RN SERIES TECHNICAL BULLETIN

MODEL : All "RN" models

ISSUE NO. : RNT-017

SUBJECT: 444-42028-009 Sensor KH0698-20
020-11754-000 Paper Sensor Cover 2
020-11755-006 Paper Sensor Cover 2 (Upper)

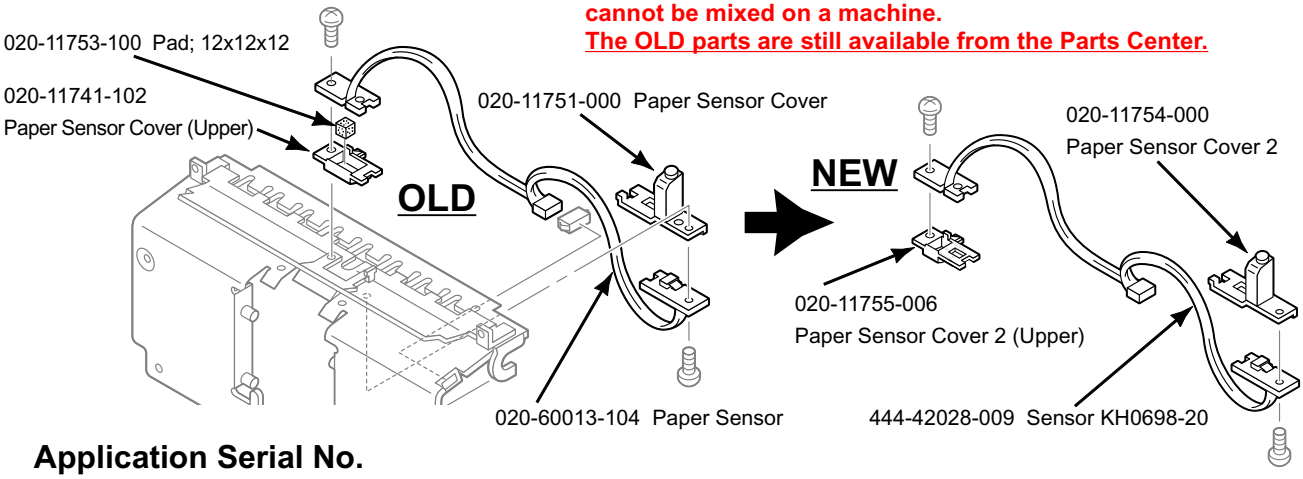
Brief:
The design of the Paper Sensor Covers are changed, and the Paper Sensor is also changed.
The sponge (020-11753-1009) placed inside the previous Paper Sensor Cover (Upper) is now omitted.

Reason:
Paper dust was reported to accumulate inside the former design Paper Sensor Covers.

Modification:
The design change is made on the sensor covers to eliminate small gap openings which allowed the paper dust to get in. The sponge, which existed inside the former upper sensor cover, is now omitted after the design change to eliminate the small gap openings.
The PCB portion of the Paper Sensor is redesigned (the shape is changed) at the same time to allow elimination of the gap holes between the sensor and the covers.

CAUTION:
If any one of the three (3) OLD type parts is to be changed to a NEW part, all three parts needs to be changed to NEW parts at the same time. The NEW parts are compatible on all existing RN machines only if all three parts are replaced to NEW parts at the same time. OLD parts and NEW parts cannot be mixed on a machine.
The OLD parts are still available from the Parts Center.
